## DESCRIPTIVE REPORT

*Registry No.* ..... H11447

*General Locality* ..... Wrangell Narrows

*Sublocality* ..... Mountain Point to Prowley Point

*Figure 2. Step artifacts in Northern Wrangell Narrows due to large vertical offsets, most likely due to inadequate water level information.*

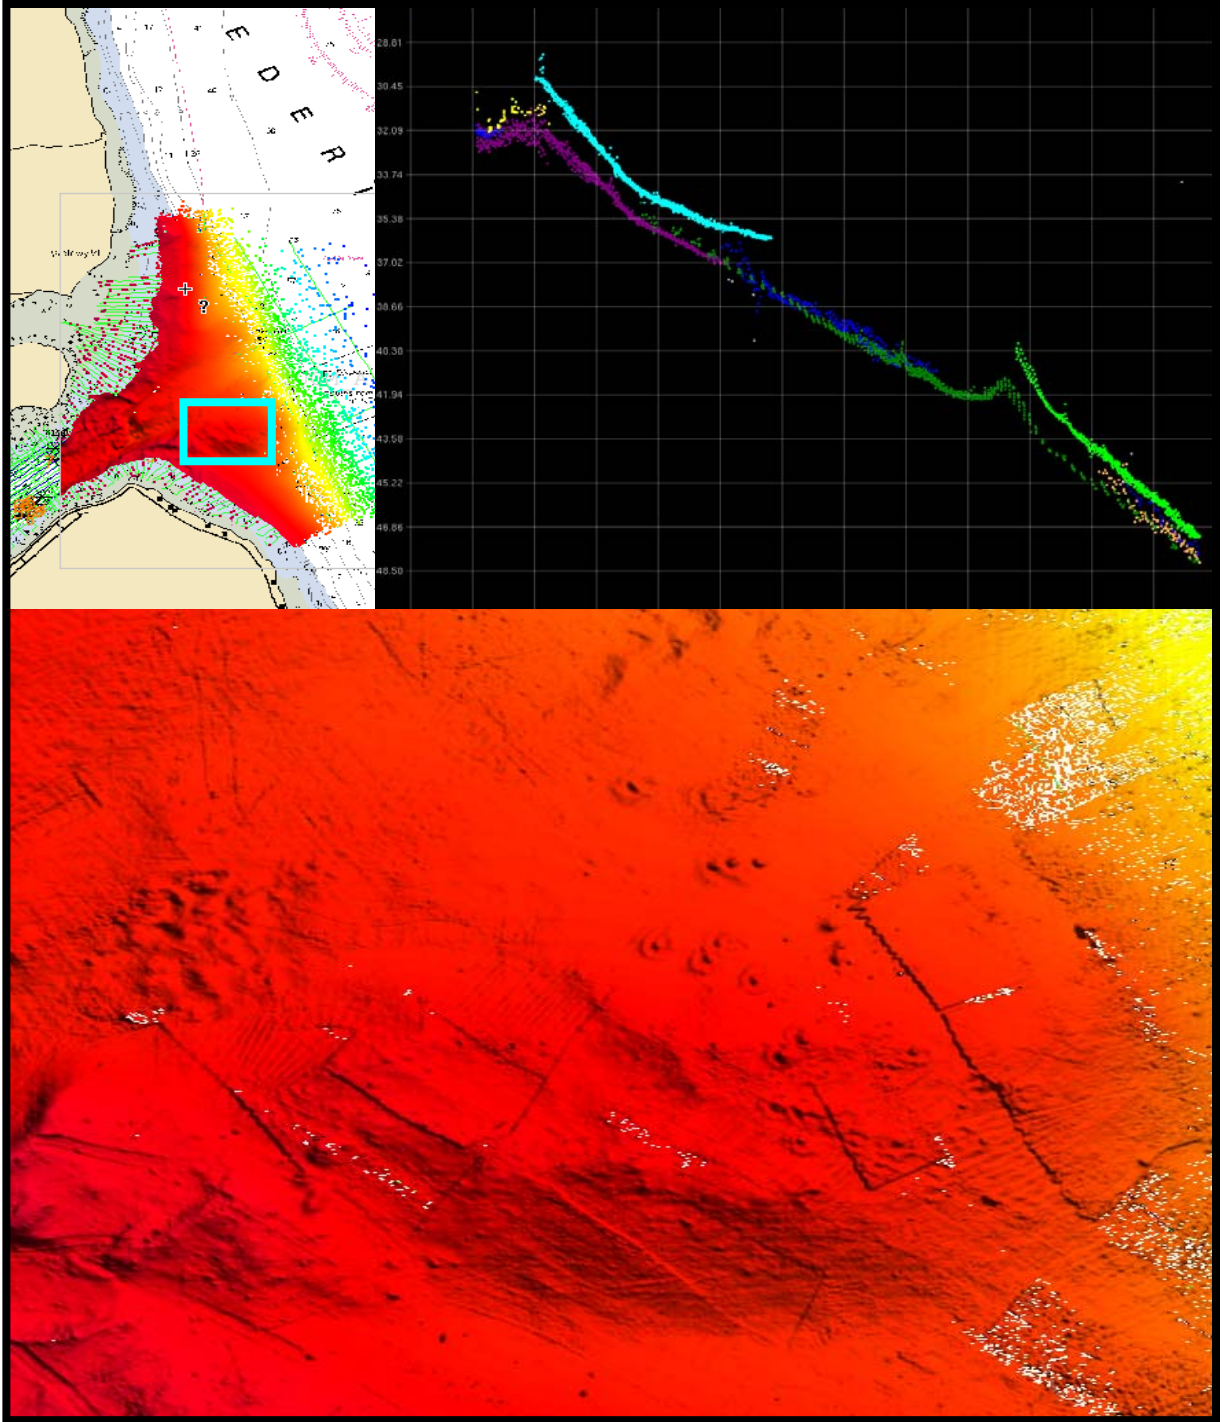
One example of vertical offsets affecting the CUBE surface is illustrated in Figure 2. The one meter resolution depth surface has a vertical exaggeration of 10, which better highlights the vertical offsets, and displays the characteristic step artifacts that result from such an error. The cross section, shown here in Caris 6.0 Subset Mode, illustrates two errant lines in this area (light blue is line number 303\_2122 and light green is line number 302\_2119). In this case, both errant lines were acquired on the same day (DN 142) by the same boat (1016). The two lines are markedly shoaler (0.5 m) than the data acquired on other days. Given the depth of water in this area, about 30-50 meters, this difference is just within IHO Order 1 specifications<sup>7</sup>. For future surveys in this area, see recommendations in D.2.h.

<sup>6</sup> All hydrographic survey data that did not meet IHO order 1 standards was removed from this survey during the Survey Acceptance Review (SAR) process.

Figure 3: Ceeducer line 541\_2252 (DN 144) vertical offset from multi-beam data (sounding depth in meters). Inset shows subset selected on chart 17375.

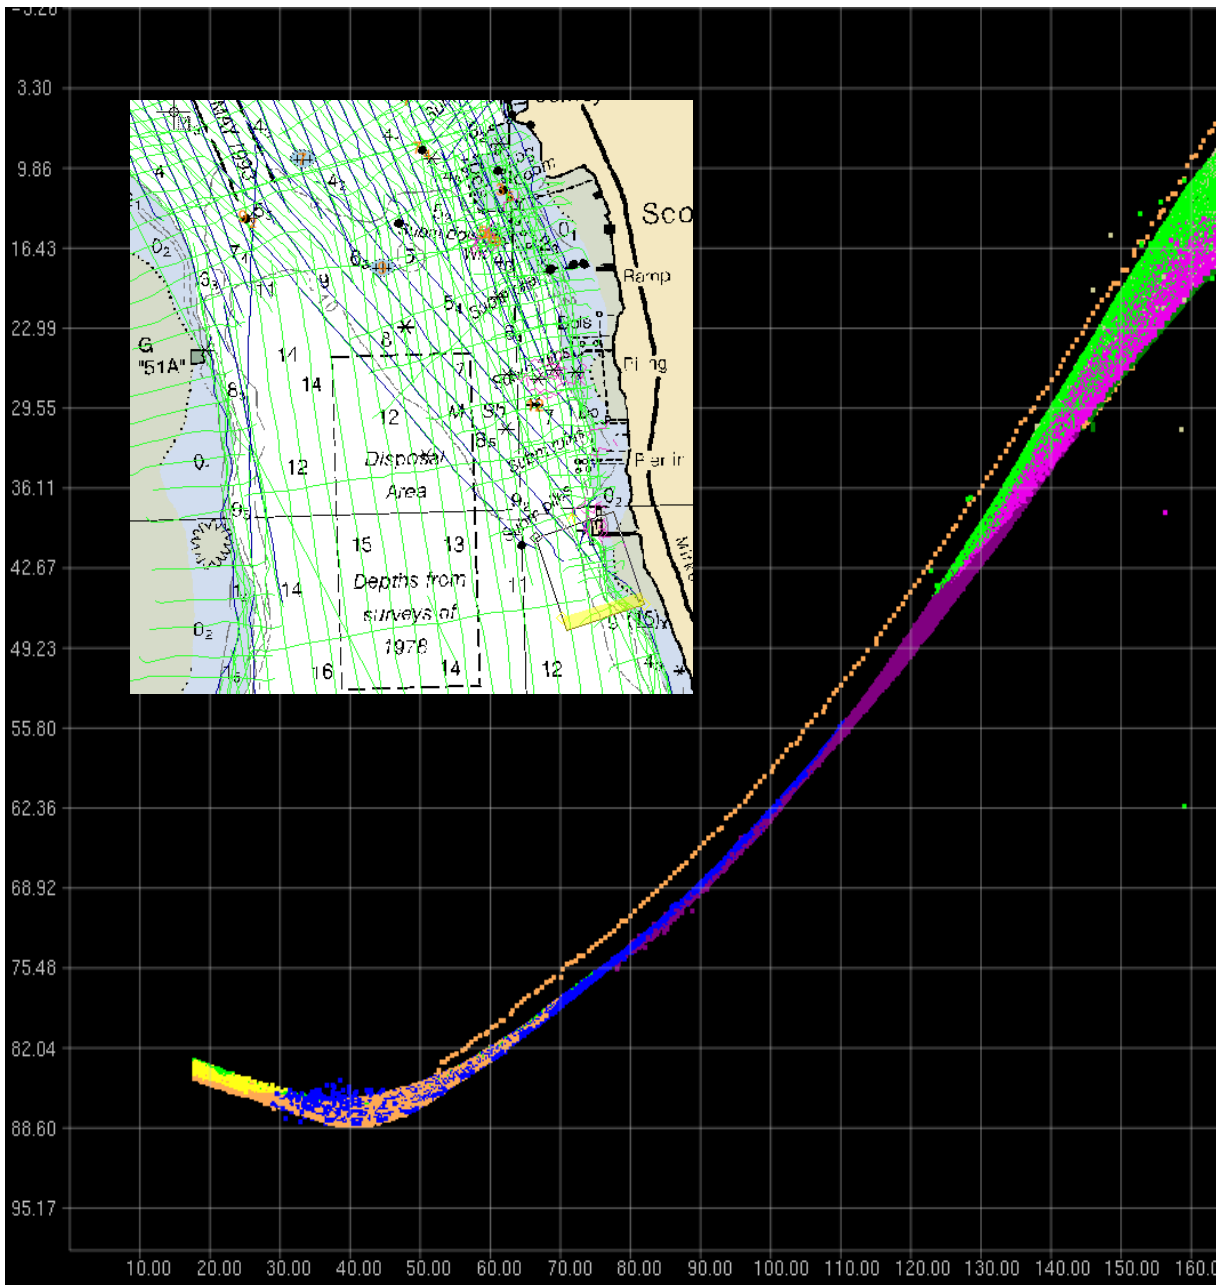
A review of Ceeducer data indicates that significant horizontal offsets were not the probable source of vertical offset error. Vertical offsets were present throughout lines and not just on steep slopes (Figure 3). Distinct bottom features covered by both Ceeducer single beam data and multi-beam data did not show signs of horizontal offsets. Thus, inadequate water levels and heave offsets are the best explanations for the observed Ceeducer vertical offsets. Ceeducer data was acquired and accepted to complete the definition of the zero meter contour in areas delineated by the project instructions and the chief of party.

<sup>8</sup> All listed lines of singlebeam exceeding IHO order 1 were excluded from compilation.

Figure 10. H11447 Cable area and Sewer Line on chart 17375.

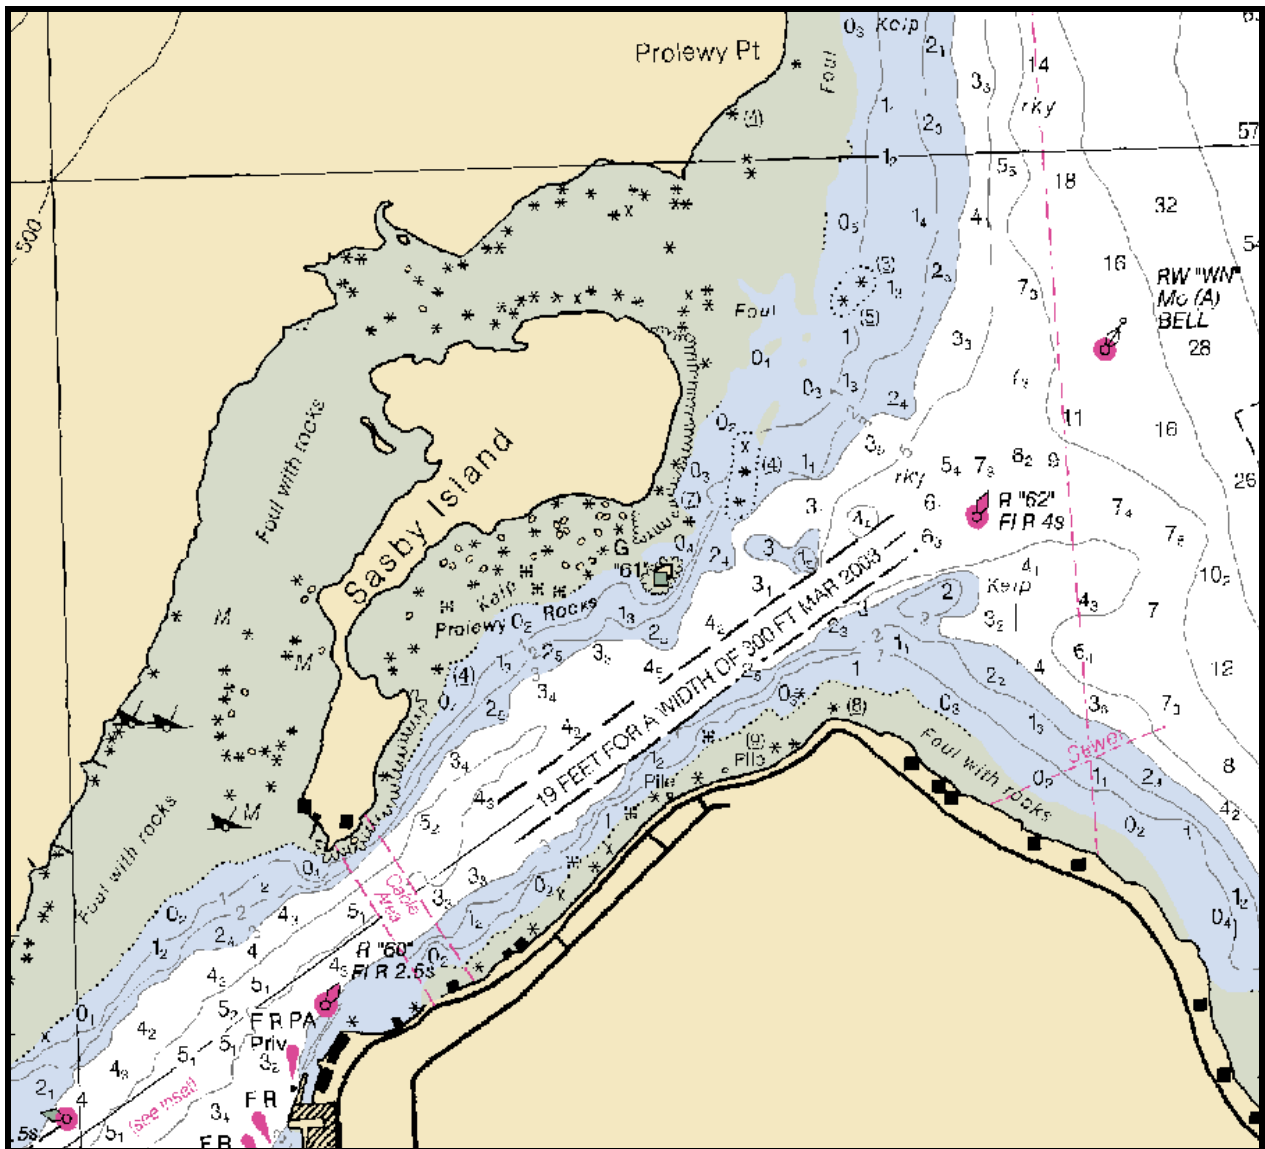
Survey H11447 includes one charted cable area with two charted cables and one sewer line, as shown in Figure 10. No evidence of the sewer line or the cables was present in the bathymetric data or in the SSS data. While there is no surface evidence of these features, the hydrographer recommends retaining the cable areas and sewer as charted.<sup>33</sup>

<sup>33</sup> Concur.
